AA TAKLA ENGINEERING, PLLC Consulting. Design. Efficiency.

Project: 111 Sandollar
Location: Cary, NC
Date: 11/1/23
Company: _____
Care Of: Shown Spears
(919)669-9462

Project: 116 Lthica lane
Location: Bunnlevel, NC
Date: 10/26/23
Company: _____
Care Of: Shawn Spears
(919) 669-9462

Project: 947 Jared Drive
Location: Linden, NC
Date: 11/3/23
Company: _____
Care Of: Shawn Spear
(919)669-9462

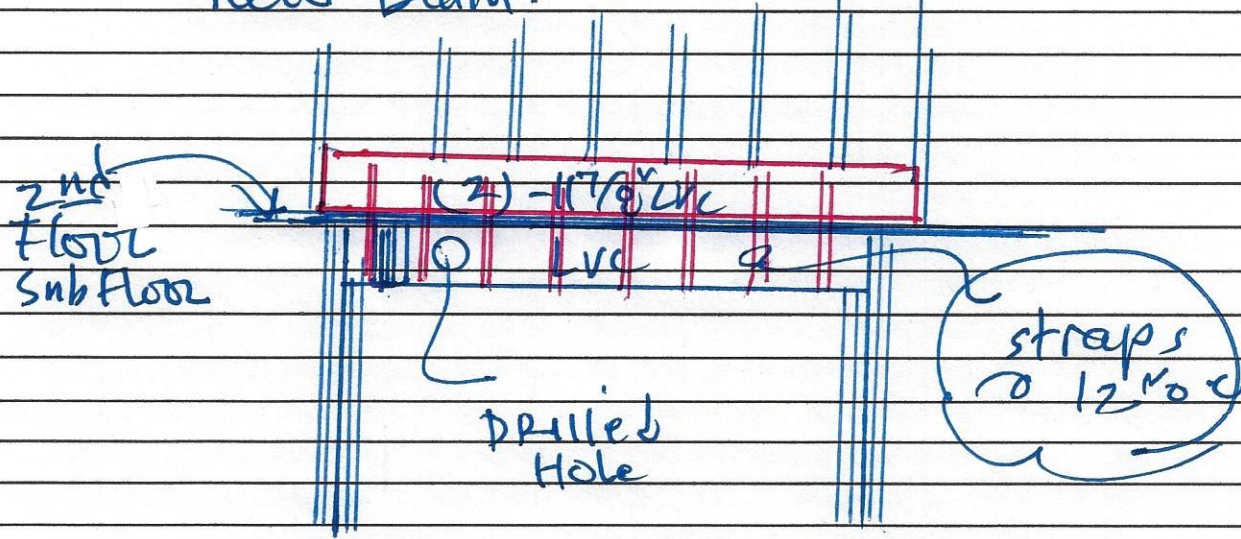
AS REQUESTED, A. TAKLA OBSERVED THE DRILLED "LVL" HEADER (over Bay Area) and we recommend that new beam (2) - 11 7/8" LVL be installed at wall above the header. Cut wall's studs larger the beam below.
- install (2) - 11 7/8" LVL (approx 12" inches larger the beam below).
- install "CS22" straps @ 12" o.c TO Hange the DRILLED BEAM TO THE NEW BEAM.
